ATR on Quality Control Check Report. (Apartments)

Flat No	B 105	QC report stage	Stage - 3	Sl. No.	38005
Company	NPL	Project	MRP	Phase	-
Prepared by	Sravanj.K	Sign	<i>[Signature]</i>	Date	2017/21
Project Manager	Subbaraj SV	Sign	<i>[Signature]</i>	Date	2017/21
Receipt by QC date	19/7/21	Sign		Other	
Receipt at HO date		Sign		Other	
Checked By MD on		MD Sign		For filling	☐ Yes ☐ No

MAYFLOWER PLATINUM

Details of Additions & Alterations

Description	Direction	Owners & Developers :	Date :	18.03.2020	Promoted by
WORKING DRAWING OF FLAT.NO.B-5		Modi Properties Pvt Ltd.	Prepared By :		Modi Properties Pvt. Ltd Phone:+91-40-66335551
		Project Name & Phase :	Approved By :	Soham Modi	
		MAYFLOWR PLATINUM	Scale :	N.T.S

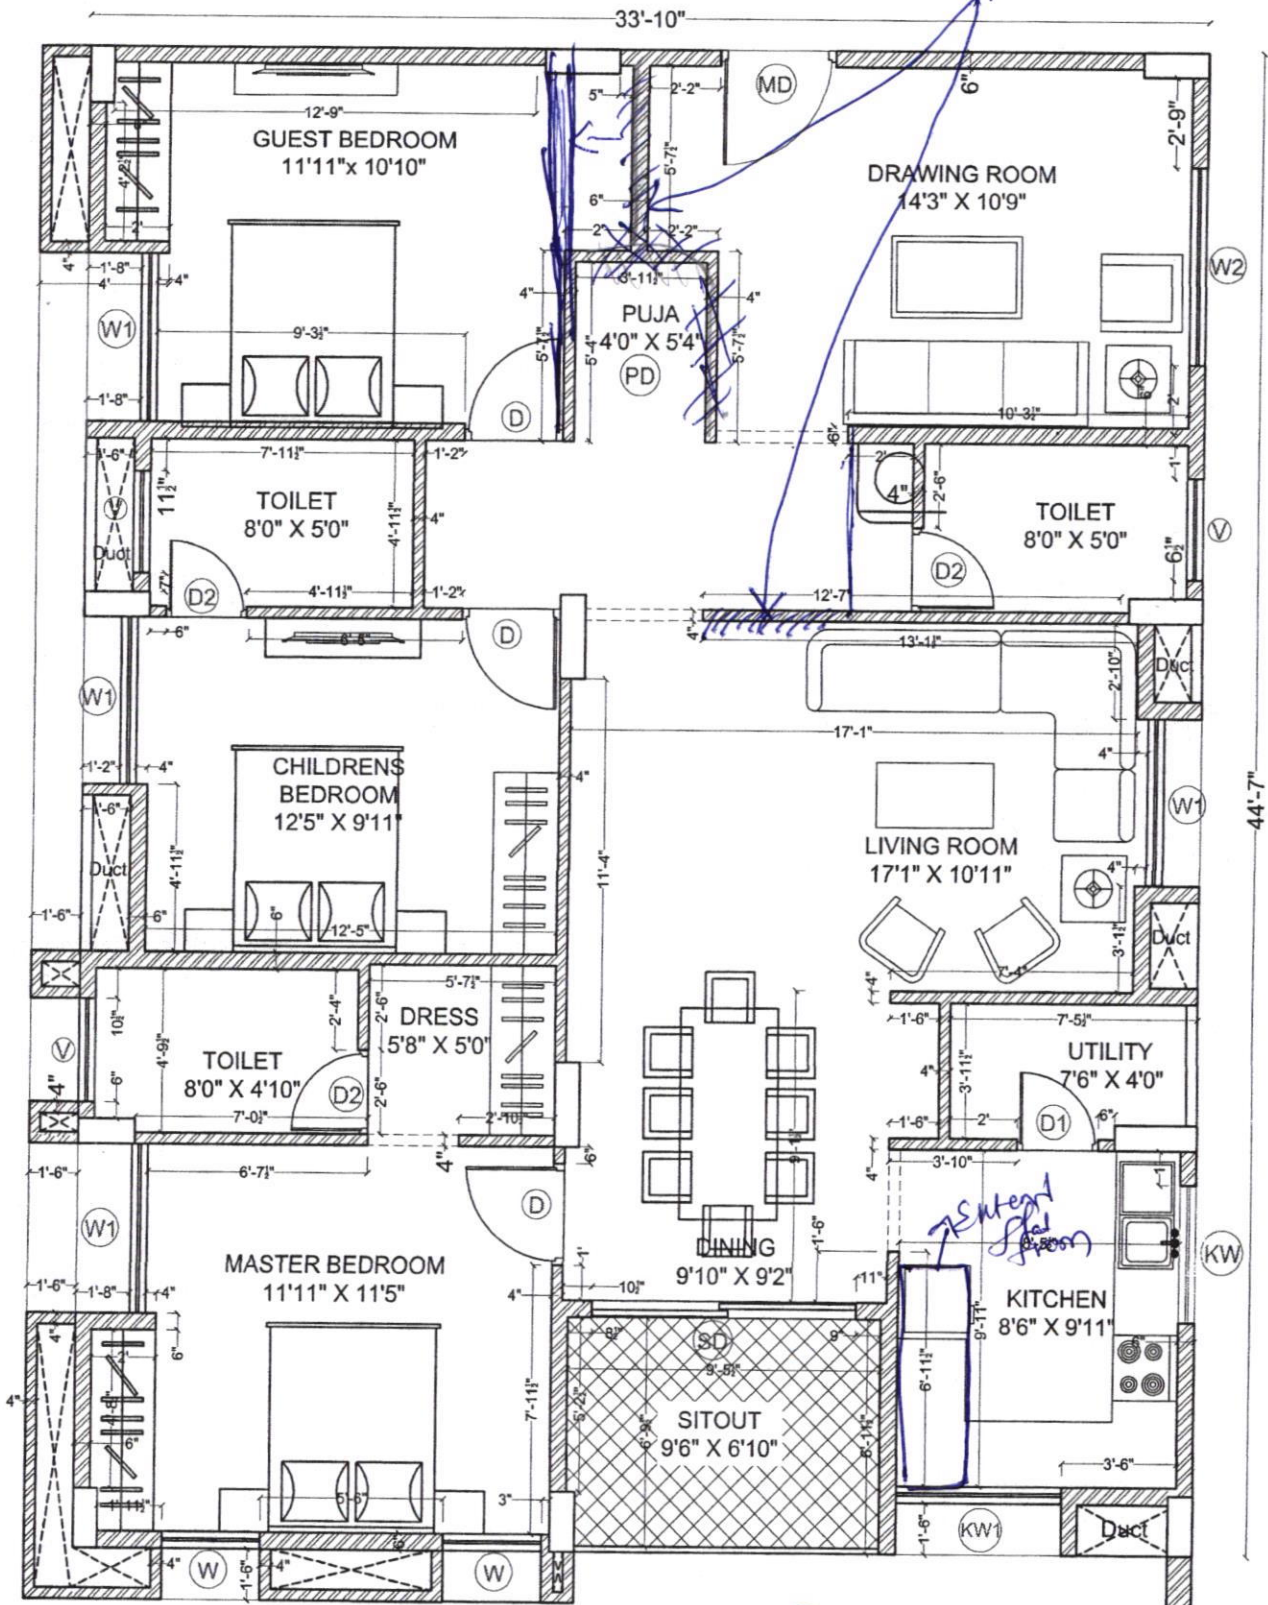
- ① All Except Kitchen are window - 3 track

To be removed

ELECTRICAL PLAN OF FLAT-B5

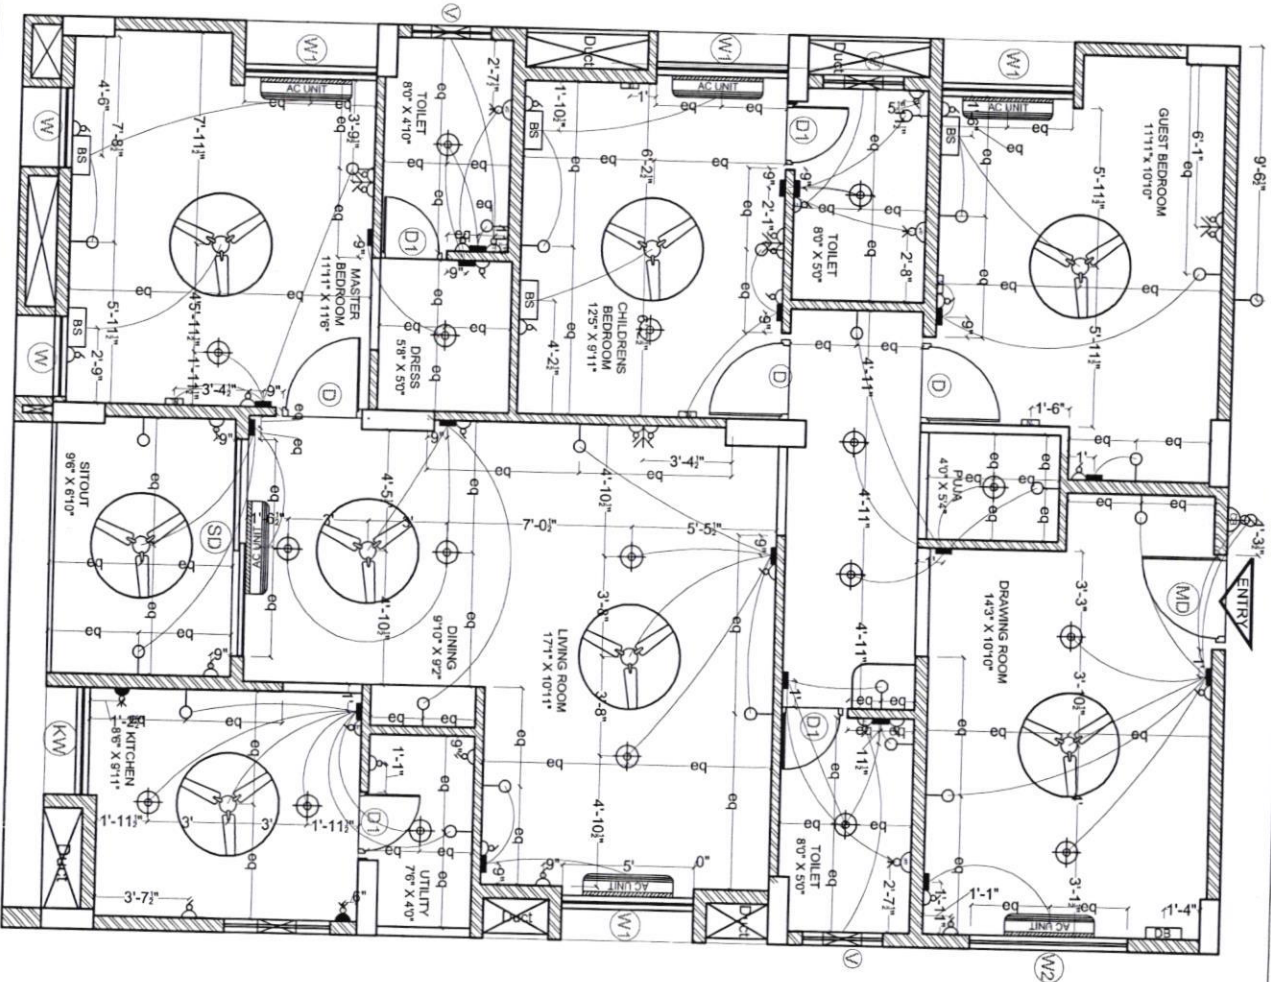
All bedrooms ^(main) Switch board with plug points
2 in dining
1 each in all bedrooms

(12 model instead of 8)
